WDNR and PSCW Questions on EPA’s Clean Power Plan Proposal

The following Wisconsin utilities are submitting joint responses to Wisconsin Department of Natural Resources (WDNR) and Public Service Commission of Wisconsin (PSCW) questions regarding EPA’s Clean Power Plan Proposal:

Wisconsin Utilities Joint Response – Submitted on September 5, 2014

CHART A

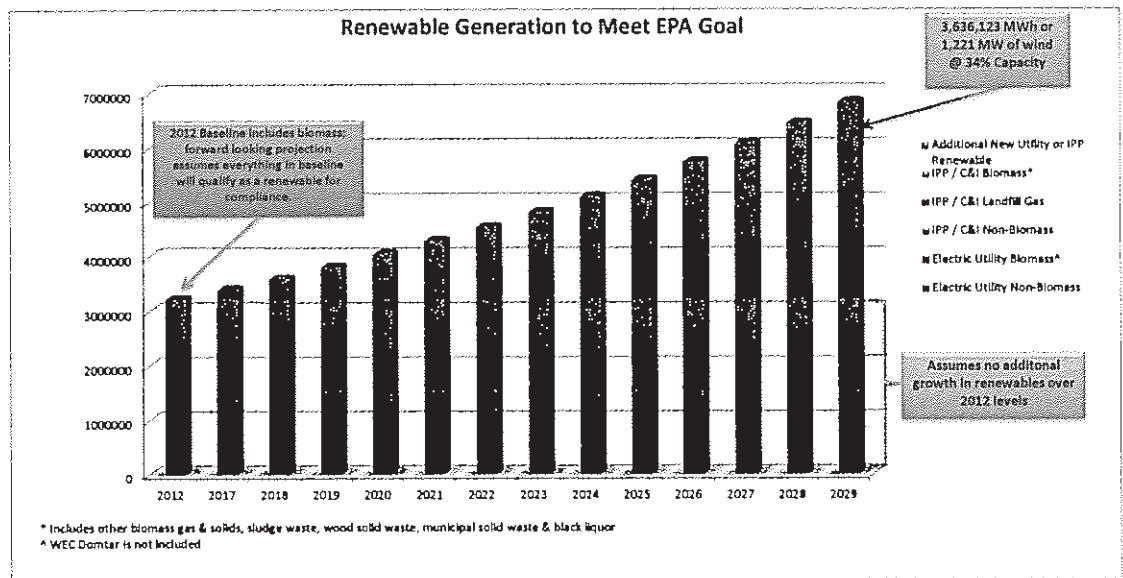
As proposed, EPA's growth rate approach is too generic. The growth rate is simply the result of a calculation designed to get the region as a whole to its prescribed renewable energy target by 2029. The annual growth rate (6%) is then applied to the State's 2012 renewable levels beginning in 2017. However, this growth rate will be higher for Wisconsin utilities because of the large amount of behind the meter renewables included in Wisconsin's 2012 baseline that is likely to remain static or decline. This translates into an annual growth rate for Wisconsin utilities that is significantly higher than 6%. There are several additional problems with this approach including but not limited to: the ability to integrate new renewable generation into transmission and distribution systems, the availability of renewable generation sources due to supply/demand limitations, and critical path limitations related to obtaining regulatory approvals. Therefore, the growth rate for renewables needs to be assessed on a state-by-state basis.

The following charts are meant to illustrate how uncertainty, as to what would be included in Wisconsin's baseline, could impact its ability to reach EPA's proposed renewable energy goals. For example in CHART-A, the 2012 EPA-established baseline included biomass facilities from all sectors. It demonstrates the needed growth rate (demonstrated as new wind generation) should all biomass be excluded. While the exclusion of all biomass for compliance purposes is unlikely, it is uncertain how biomass will be treated in the compliance phase. CHART-B demonstrates the needed growth rate should all biomass included in the baseline be allowed for compliance.
